Aperia is clarifying the torque recommendation for the trailer bracket mounting screws (Fig. 1) to ensure that the hub cap manufacturer specification is 16 ft-lb or above. The screw torque should be inspected at each PM to ensure the Halo system and hub cap remain securely attached to the vehicle.

All trailer mounting brackets, part numbers BR-DNB, BR-DPB, BR-4009A, BR-4195A.

Figure 1. Trailer bracket mounting screws

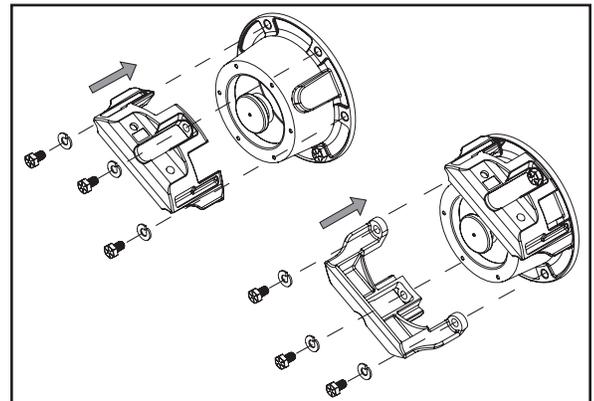
The trailer mounting brackets have been engineered to exceed the Halo's advertised lifetime. Ensuring proper torque and regularly inspecting to maintain proper torque will ensure continued safe operation. Since the Halo is typically removed to check hub lubricant levels at each PM, Aperia recommends synchronizing the torque inspection with the PM.

Confirm your hub cap manufacturer's screw torque specification is at or above **16 ft-lb**.

DO NOT install the Halo on a hub cap with a torque rating below 16 ft-lb. Replace the hub cap with a different hub cap if necessary.

Torque: 16 ft-lb (22 N m)

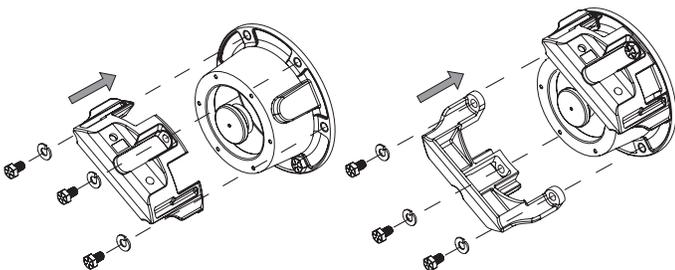
The original screws that were used to attach the hub cap to the hub may be too short to allow sufficient thread engagement once the brackets are installed.

Make sure that longer Aperia-issued screws and washers are used to install brackets. To obtain replacements contact customer service.

▲ WARNING: Failing to use the longer Aperia issued screws may lead to the Halo detaching from the vehicle during driving. Ensure that at least six threads engage with the hub when installed.
